CENTRAL FILE COPY
TECHNICAL NOTE

T/N-14

Bureau of Land Management U.S. DEPARTMENT OF THE INTERIOR

FORD TRUCKS - PARTS AND SERVICE RECOMMENDATIONS

Figure 1 - Parking Brake Lever "C" Series

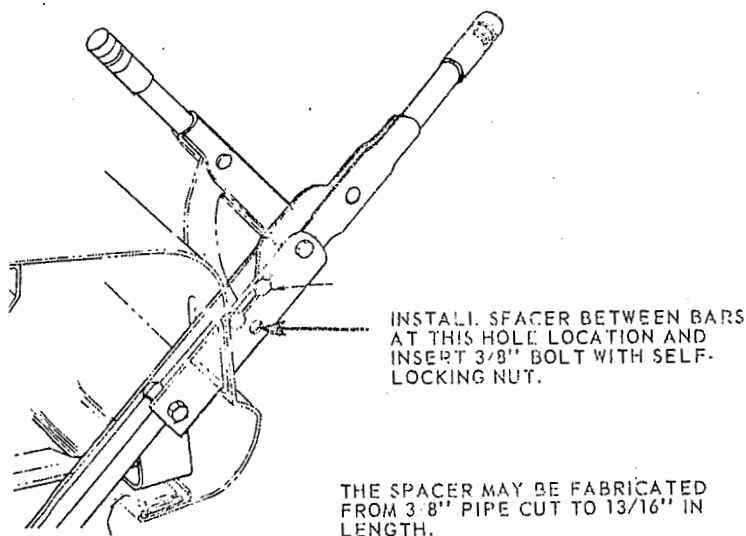
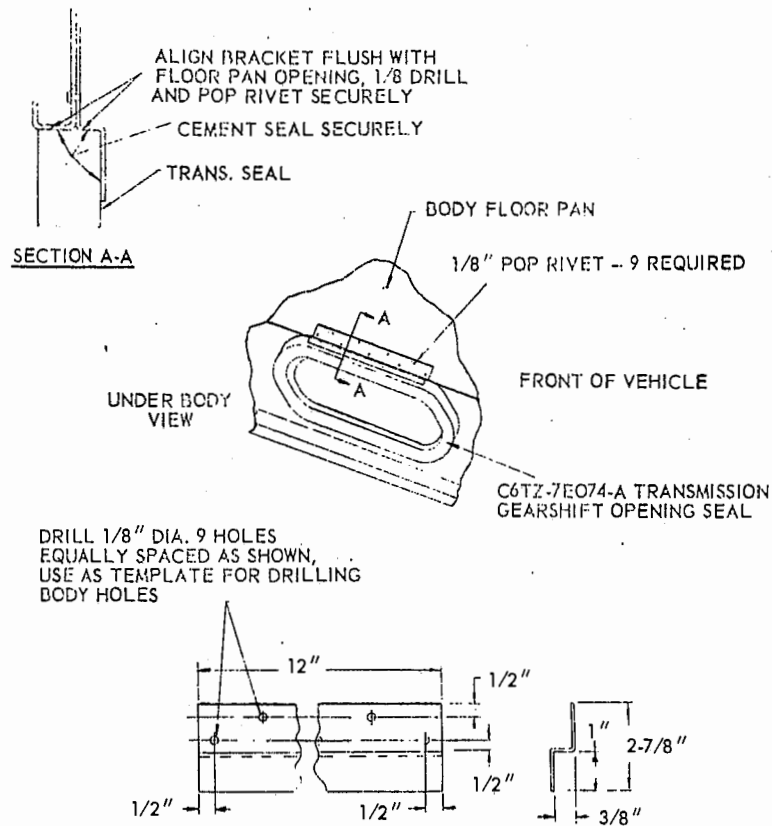
Effective September, 1968, the Orscheln parking brake lever on "C" Series trucks was revised by incorporating an additional spacer and rivet in the slot area between the two support bars. This change was made to reduce the possibility of the bars deforming if the parking brake lever is used as a grab handle when entering the cab.

The new lever is available for service under part number C5TZ-2780-B and can be identified by the presence of a rivet and spacer in the hole shown in Figure 1.

Parking brake levers on vehicles in service may be updated by inserting a spacer between bars and installing a 3/8" bolt and nut in place of the rivet used on production assemblies.

Figure 3

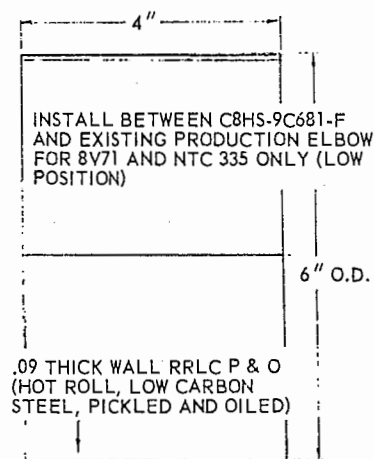
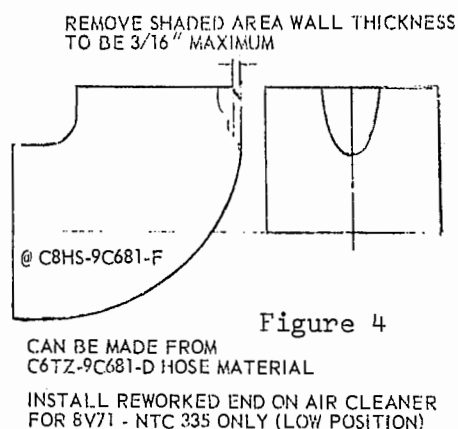
Chart 1 and Figures 3 and 4 list parts required to convert the oil bath air cleaner with minimum rework. The parts listed are DSO or RPO released.

* Parts are required to adopt new cleaner to the existing system. The oil bath cleaner for the 8V71 and NTC 335 engines incorporated a metal elbow. The new dry cleaner does not have the metal elbow and therefore the additional rubber elbow and sleeve are required to complete the installation as shown in Figures 3 & 4. The rubber elbow must be reworked by removing a small section of rubber as shown in Figure 7 to allow the hose to properly fit onto the cleaner outlet.

Figure 5

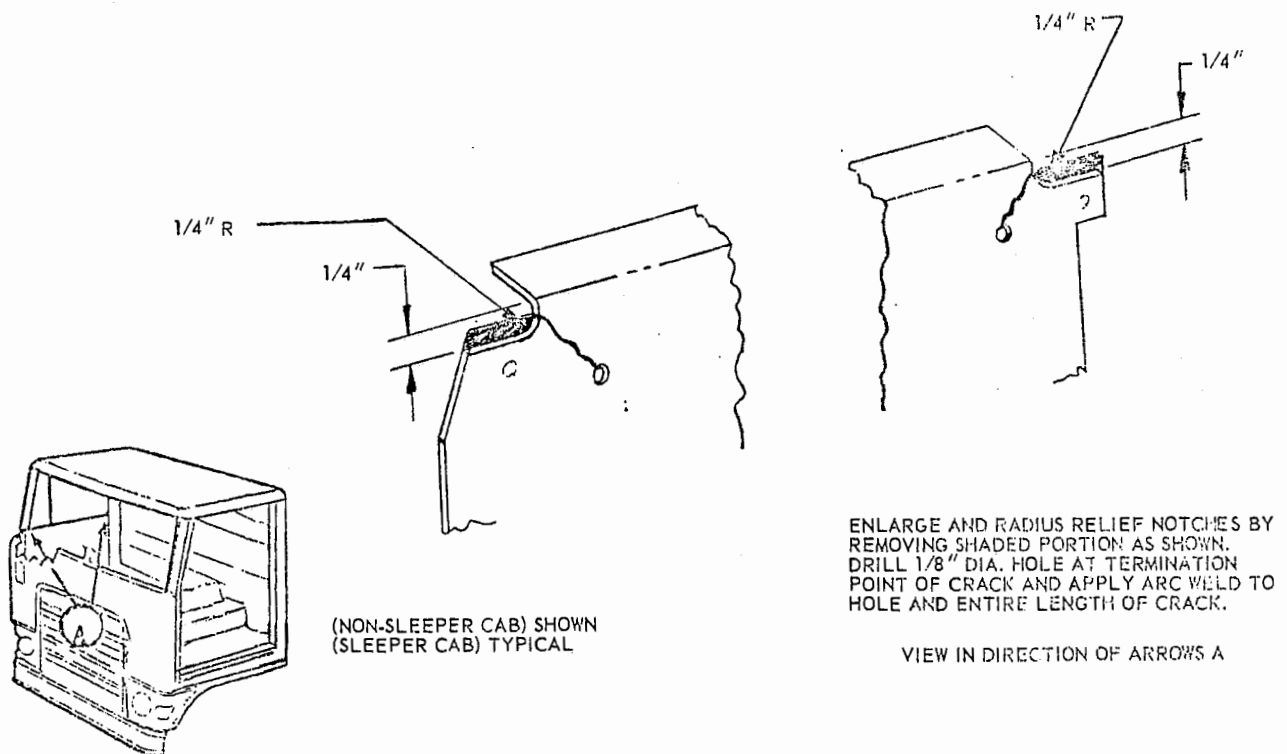
If sheet metal cracks occur at the front and rear belt relief notches of the door inner panels, the following procedure should be used. The production correction which enlarges the radius in the relief notches by removing metal from the vertical and horizontal trim lines was incorporated during July 1968.

1. Remove the door inner upper panel as described in the 1968 Truck Shop Manual, Volume Three, Page 17-54.
2. Drill a 1/8" diameter hole at the termination point of the sheet metal crack.
3. Enlarge and radius the front and rear belt relief notches on the door as shown in Figure 5.
4. Apply arc weld to the drilled holes and the entire length of the cracks.
5. Metal finish and repaint the repaired area as required.

Figure 6

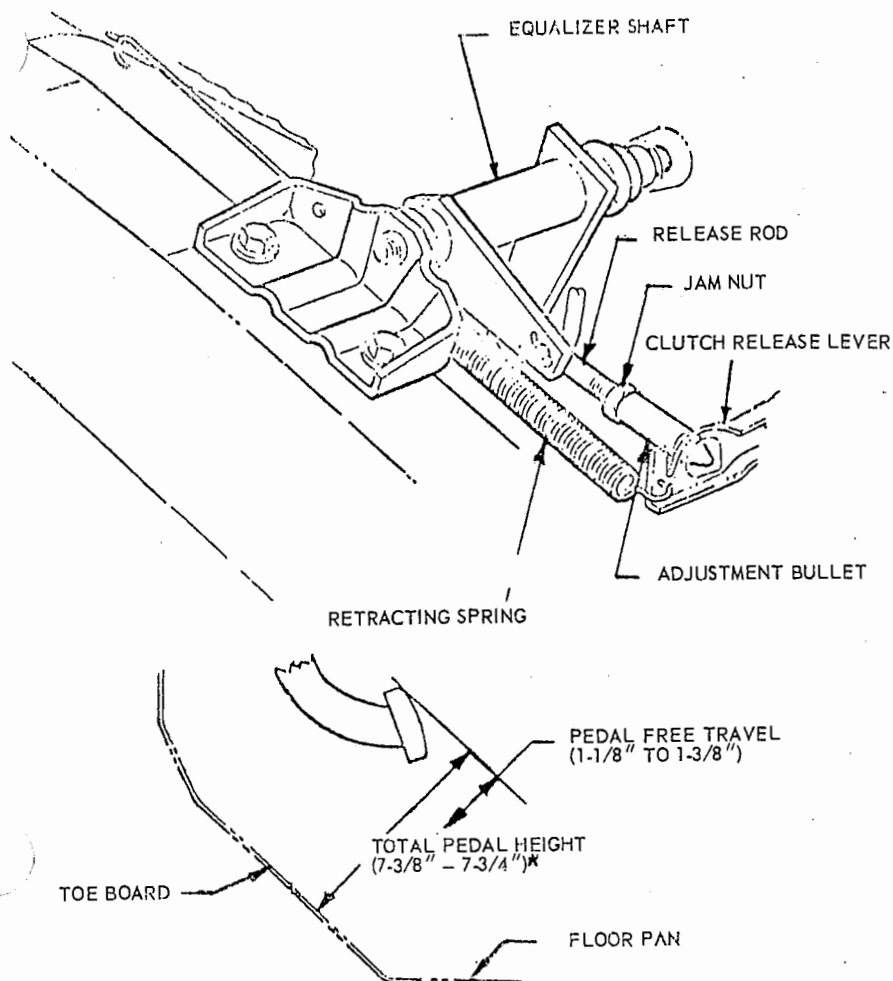
The clutch pedal "free travel" at the release rod "bullet" has been revised to .200 inch. To correctly adjust "free travel" follow this procedure:

1. Make sure the retracting spring is attached to the clutch release lever.
2. Loosen jam nut and back off five (5) or more turns.
3. Turn release rod "bullet" lightly against the clutch release lever facing. Use caution not to force "bullet" against the clutch release lever causing it to move against the retracting spring.
4. Place .200" gauge between the release rod "bullet" face and jam nut.
5. Return jam nut against gauge.
6. Remove gauge.
7. Hold jam nut in this position and rotate release rod "bullet" against the jam nut and tighten. (Torque specification is 12/18 ft.lbs.)

NOTE: The clutch pedal height dimension remains at 7.38" - 7.75". Free travel at pedal pad is 1-1/8 to 1-3/8 inches.
